STATE OF MAINE
DEPARTMENT OF TRANSPORTATION
16 STATE HOUSE STATION
AUGUSTA, MAINE
04333-0016

December 28, 2006
Subject: **Topsham**
Pin No. 14062.11
Amendment No. 2

Work under this contract is generally described as the construction of the MaineDOT TOPSHAM HIGHWAY MAINTENANCE GARAGE

SECTION D-D
3/8" = 1'-0"

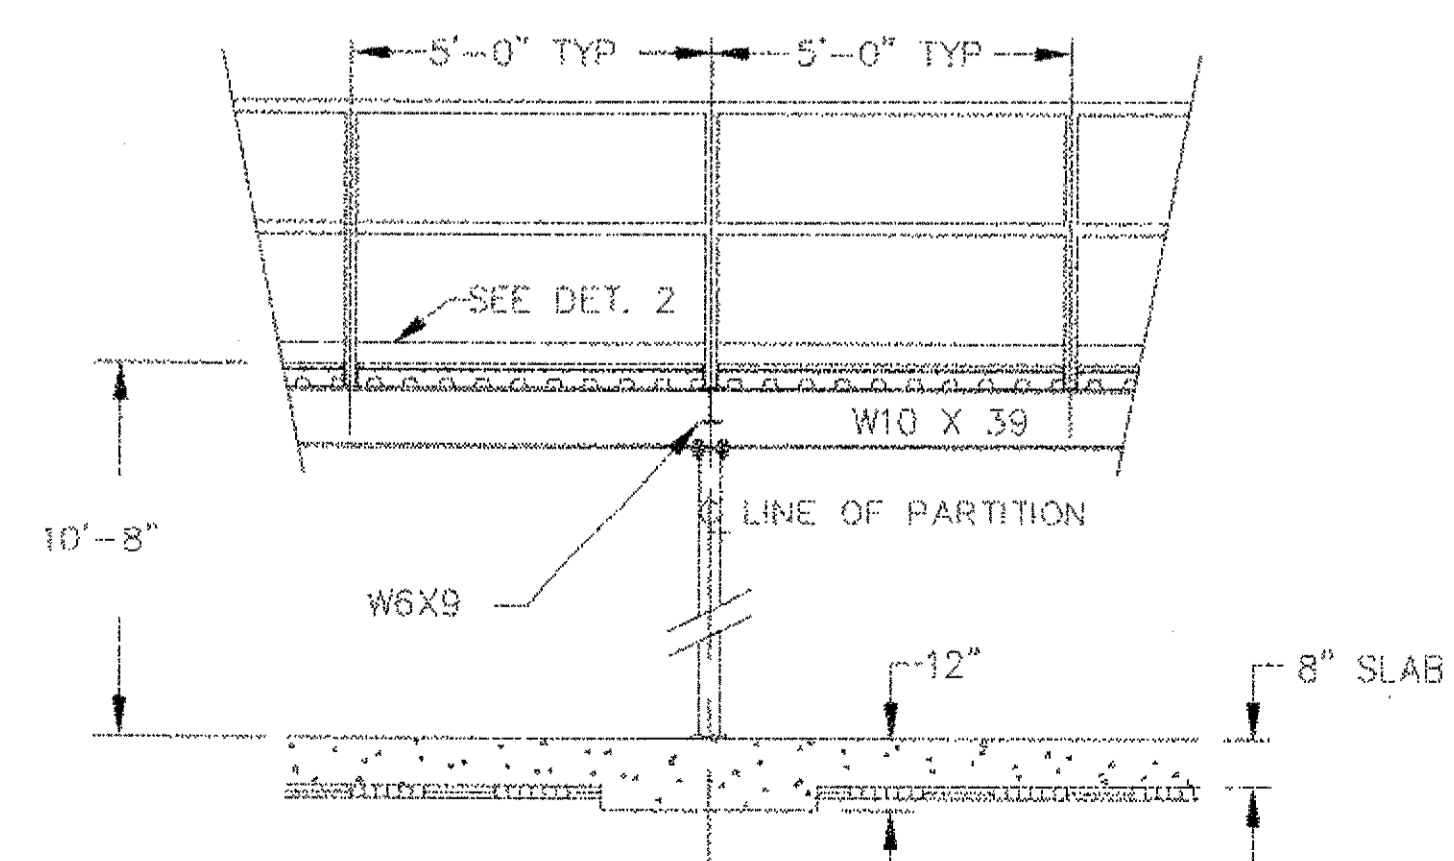
Question: On drawing MZ-2 Section A-A, is this footing detail only on line shown, or at all columns? It is not shown on Section C-C.

Question: On Drawing MZ-2, there are no dimensions, clear layout, or description of structural elements.

Question: Drawing MZ-2. What is construction of stairs?

Response: Drawing MZ-2 has been removed and replaced by the attached plansheet A-5A, and revisions have been made to Section A-A.

Response: The structural members have been identified on the attached A-5A plansheet.

Response: Stair details have been added on the attached A-5A plansheet.

DATE	SCALE	JOB NO	DRAWING NO
05-19-06	AS SHOWN	LP ENG 300-01-06	A-2B

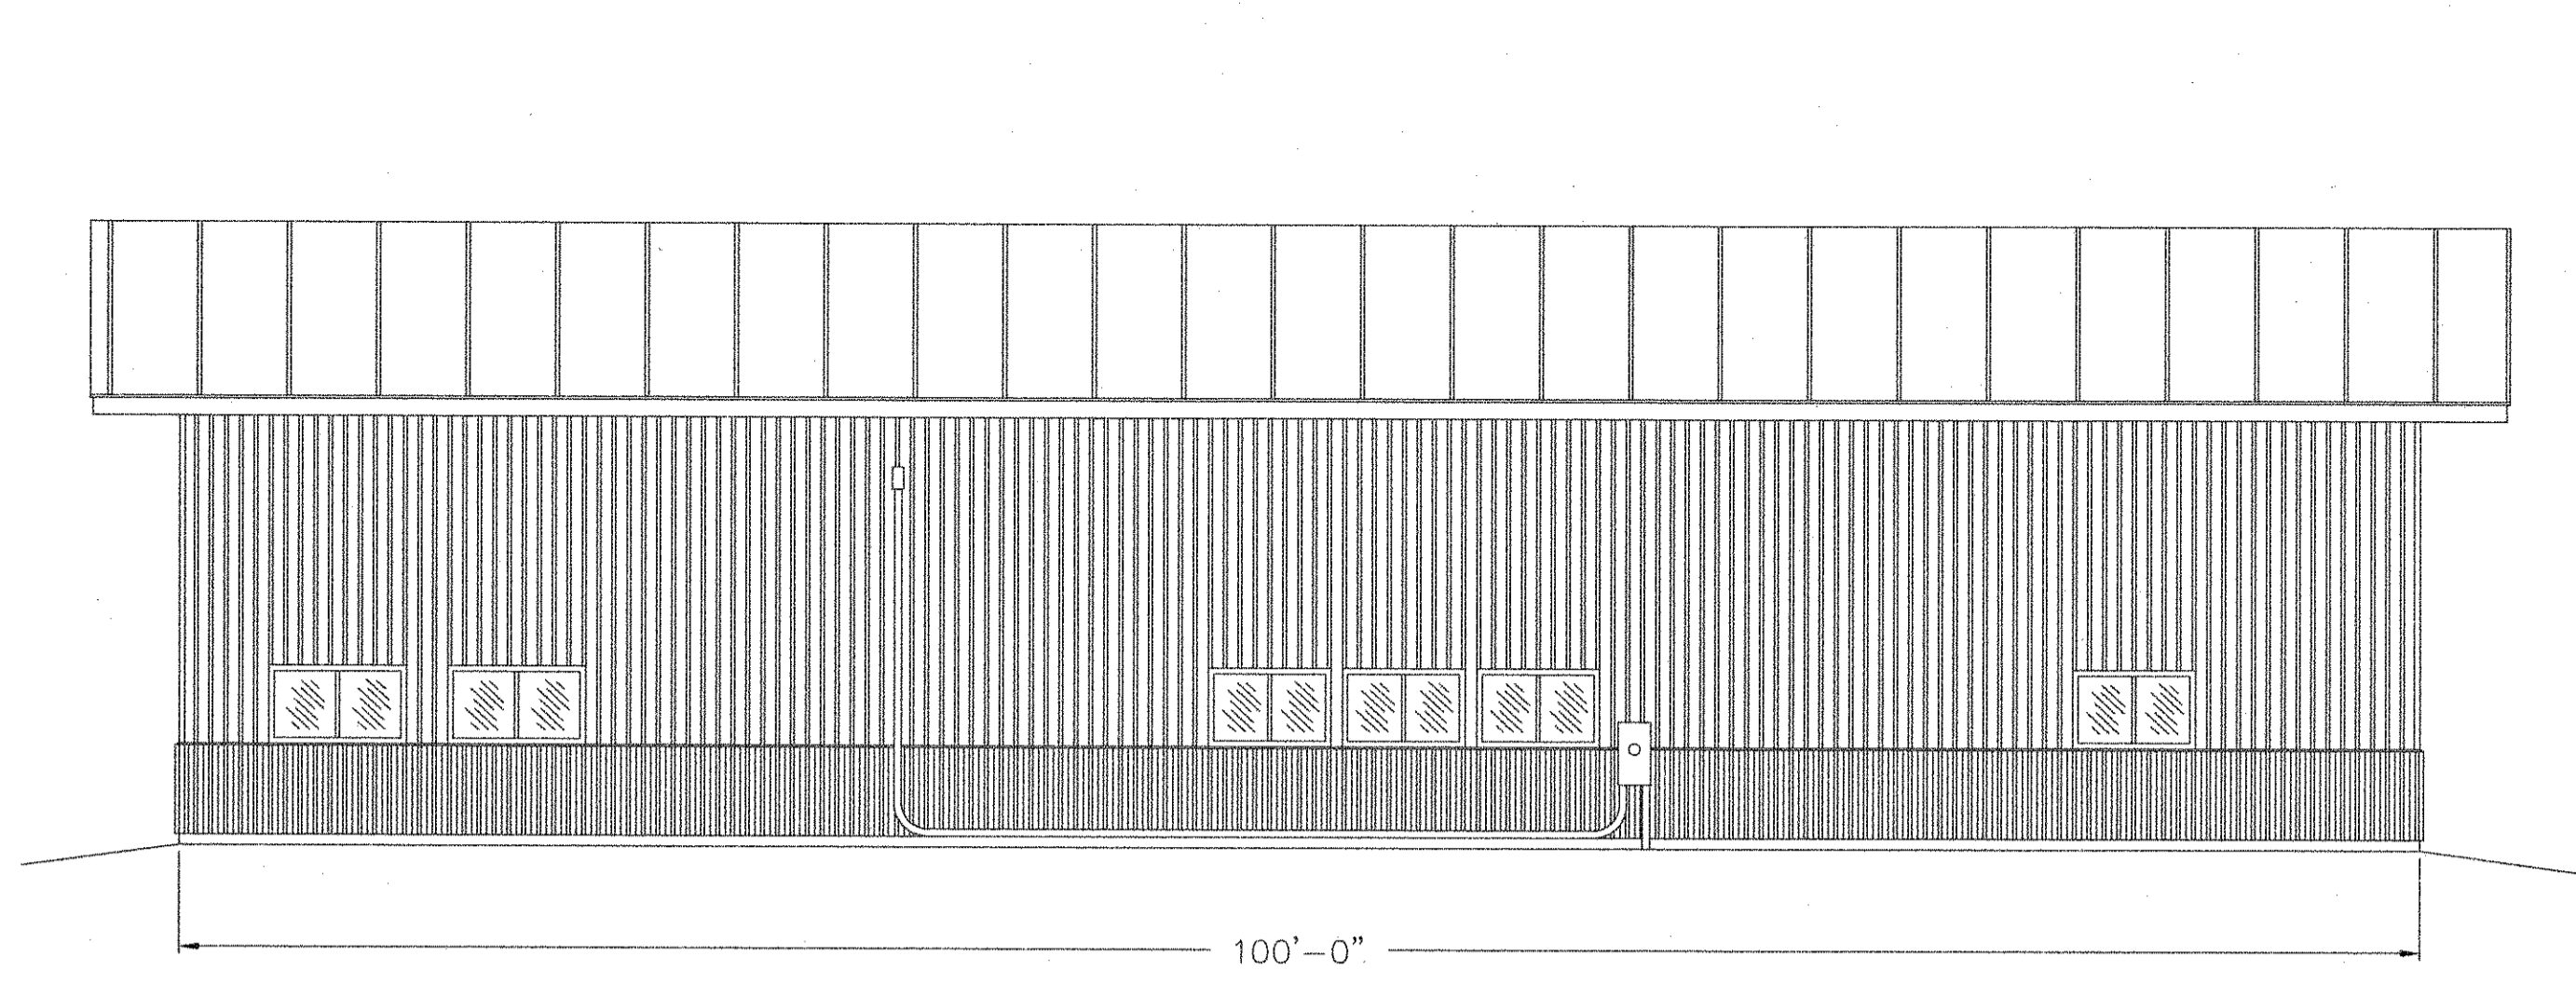
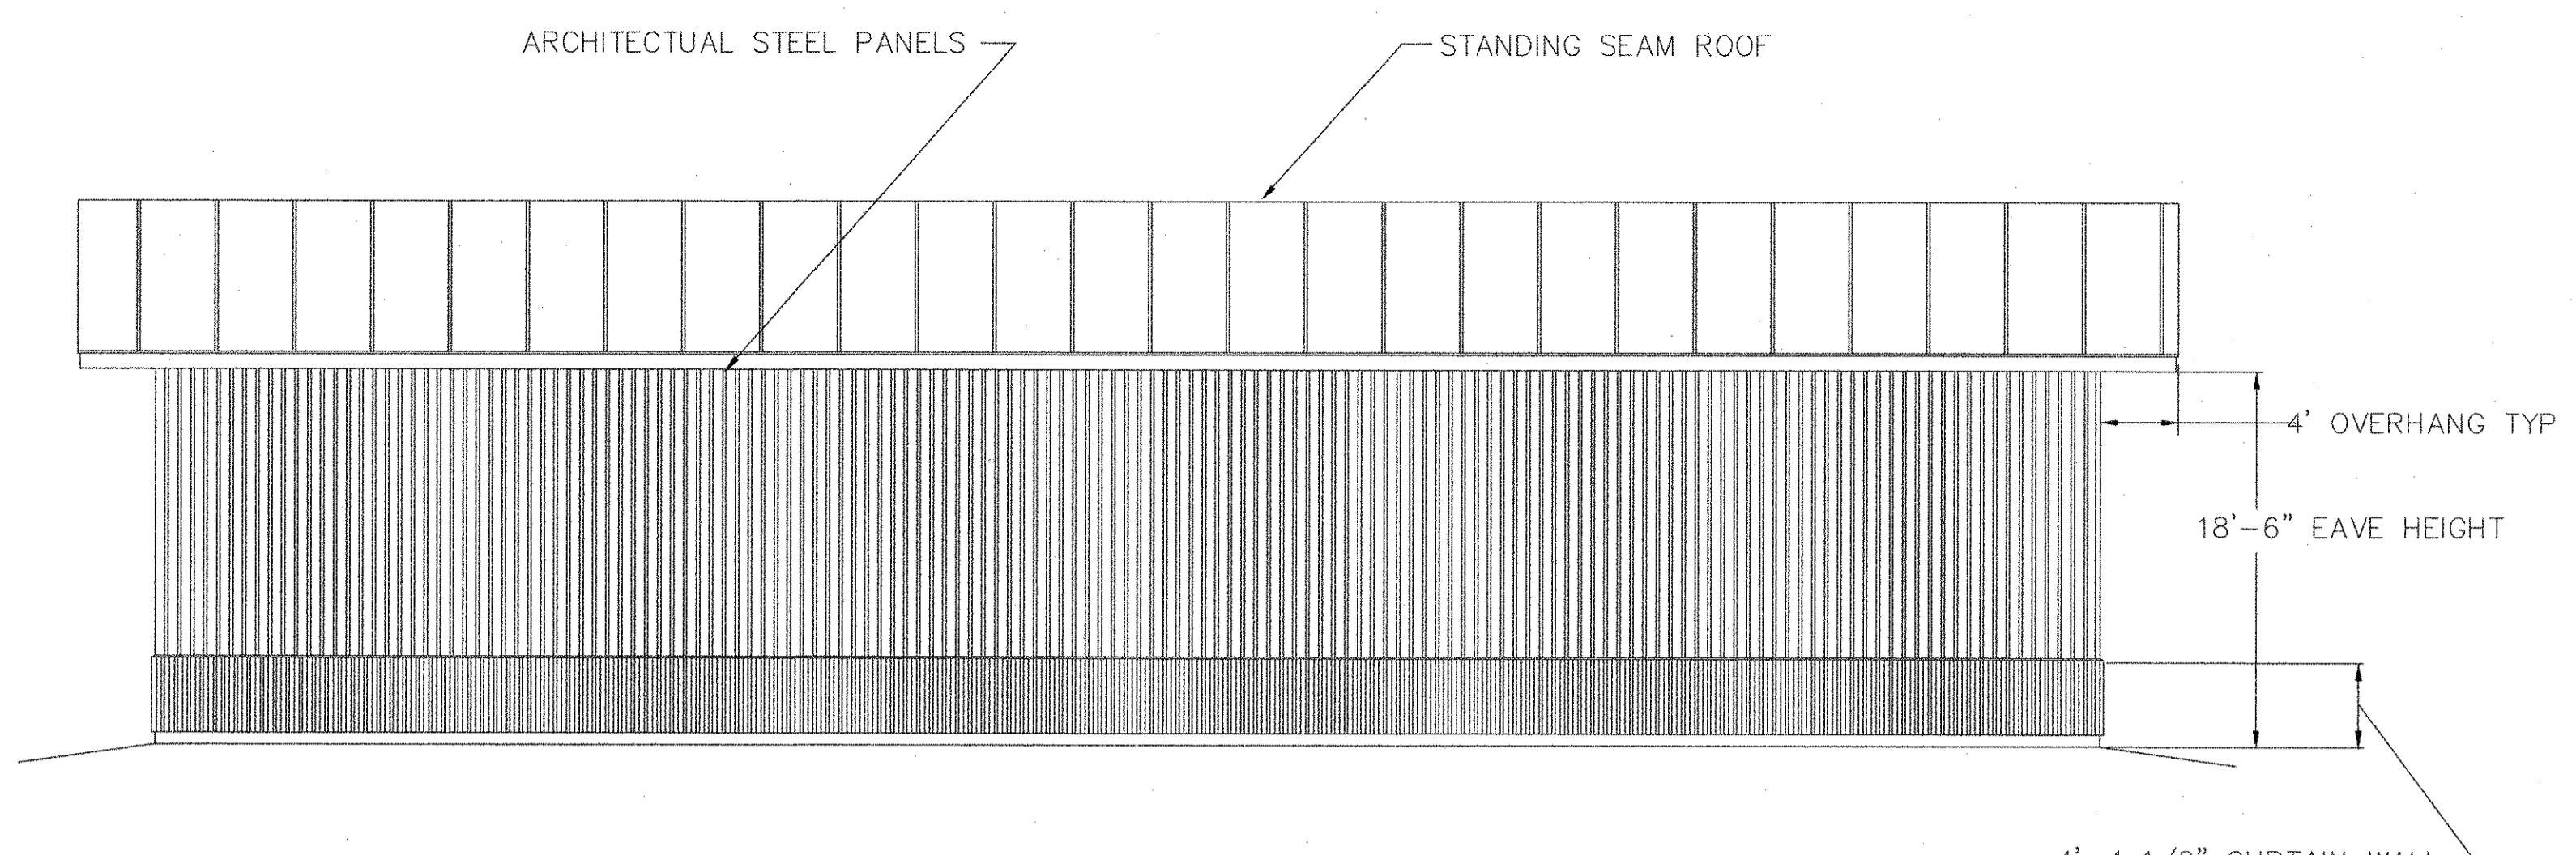
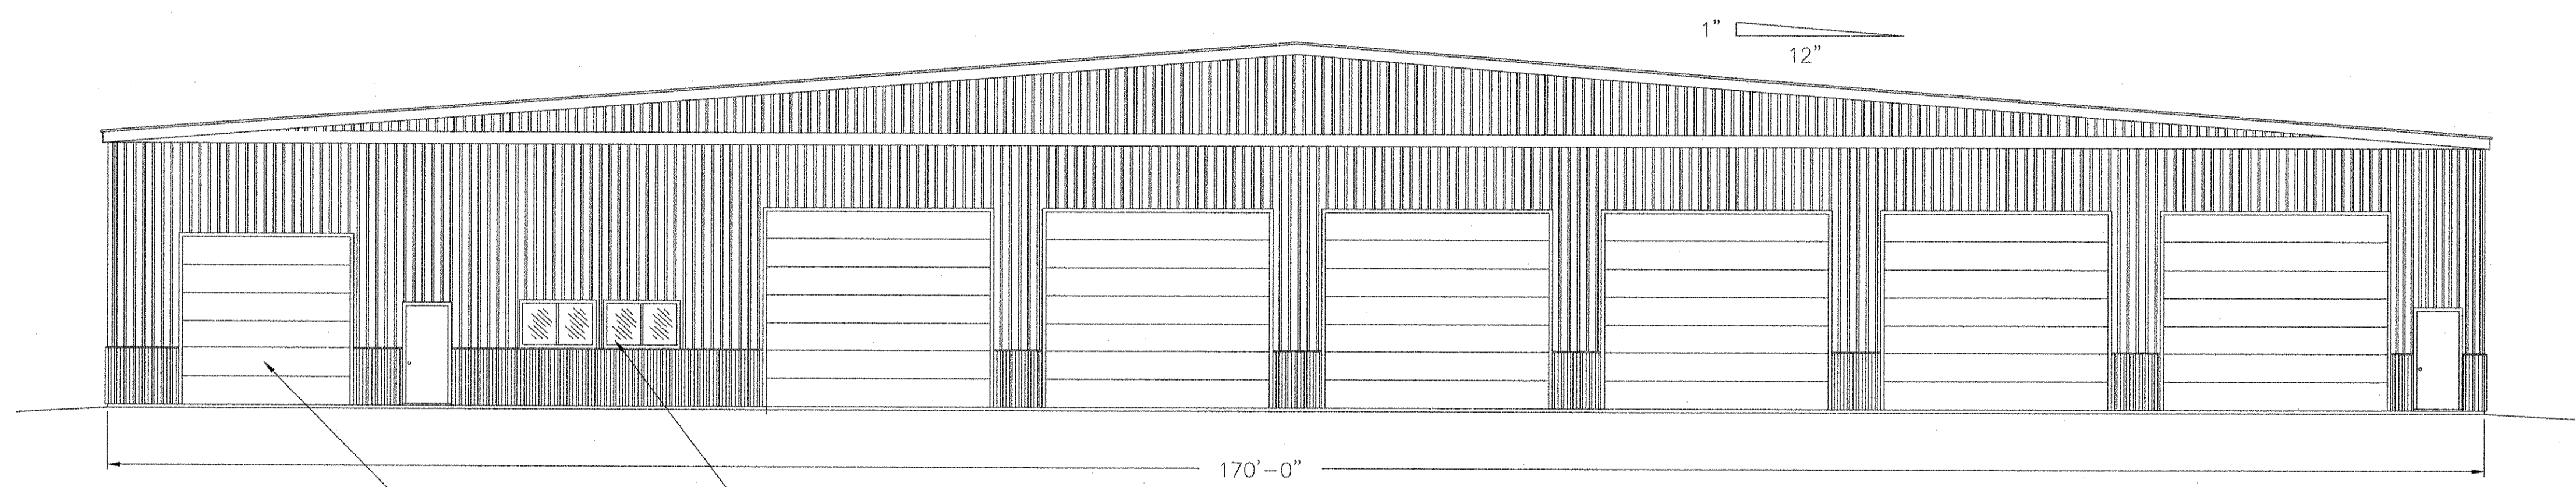
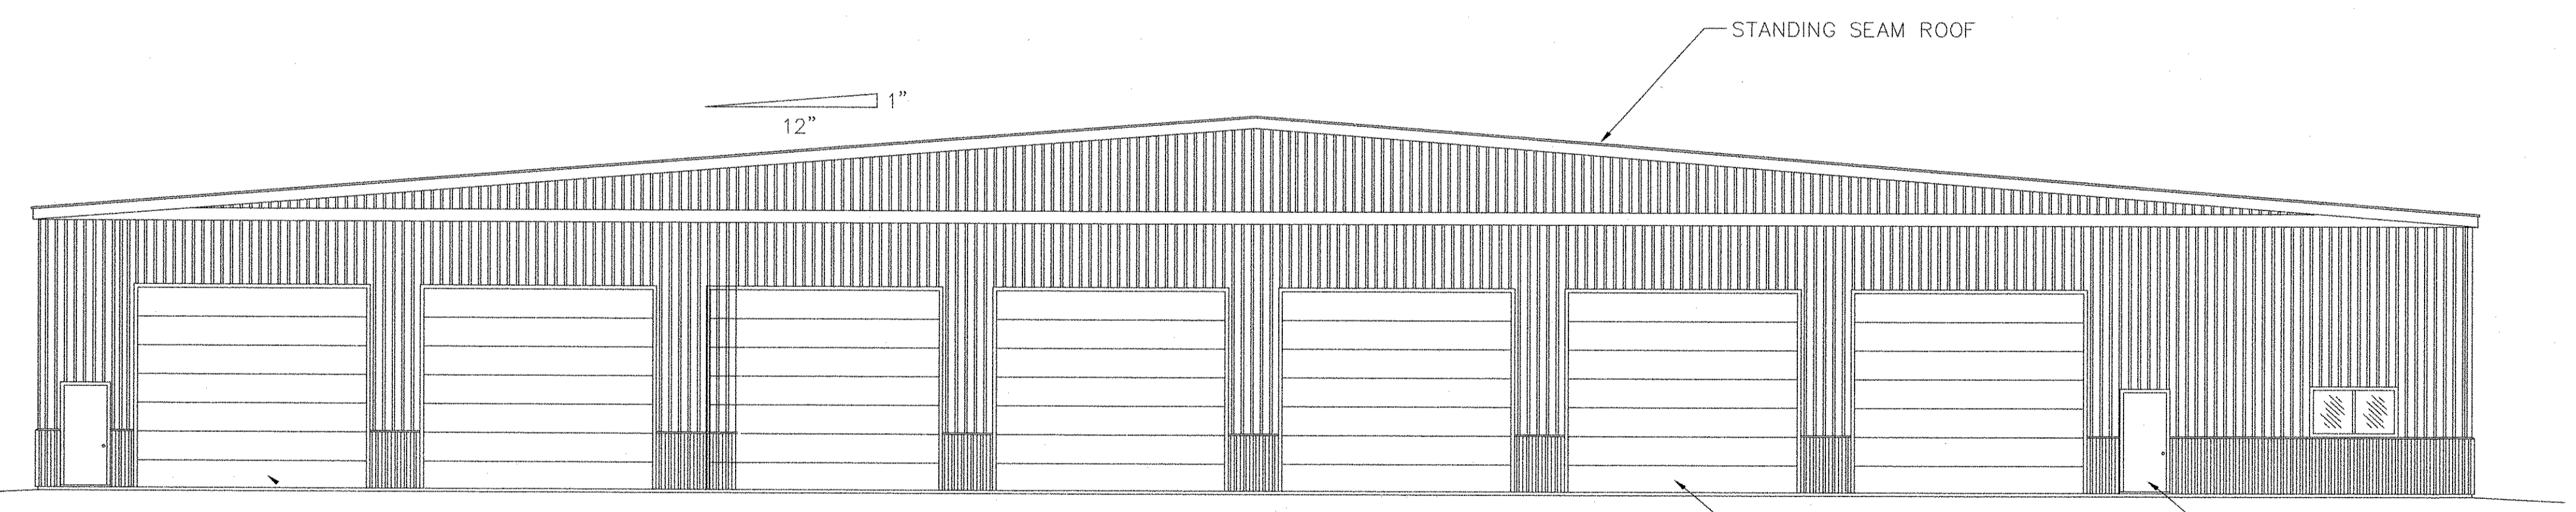
Question: The elevation drawings show (7) overhead doors on the front and (8) on the rear. The plan view appear to show only (7) in the rear.

Response: There are seven doors in the rear. This has been corrected and shown on the attached updated Drawing A-2B.
